Subject: Request for additional information regarding FCC ID: IHDT6GM1

Correspondence Reference Number:	IHD0507
Confirmation Number:	1608280507/508
Date of Original Email:	October 9, 2006

Figure 1. Part 15 Radiated Test Set-Up

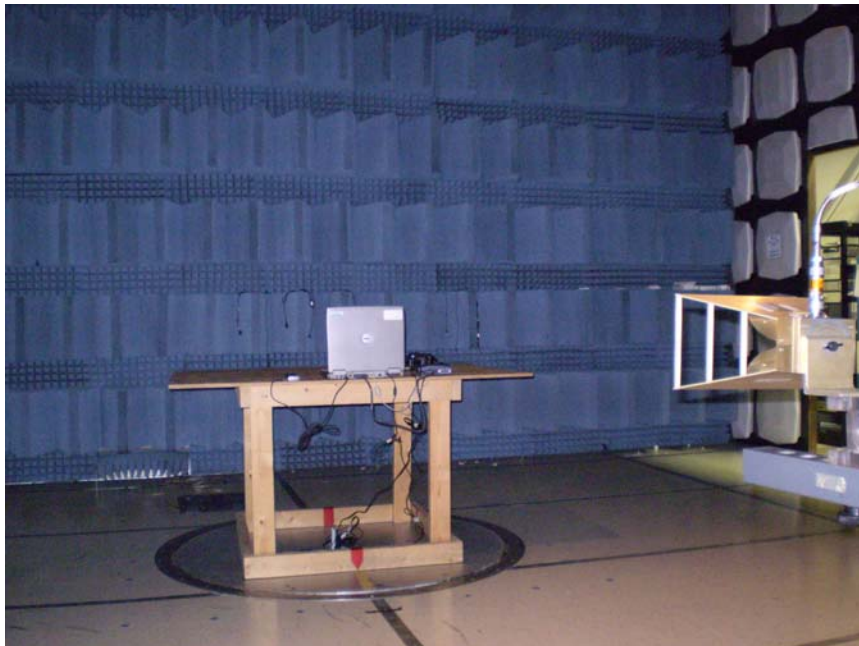
2. Please submit Part 15B test set up photos (both radiated and AC Line Conducted) as well as Part 24 EMC test set up photos (the test set up photo submitted does not show the EUT).

Response: Please refer to the following photos:
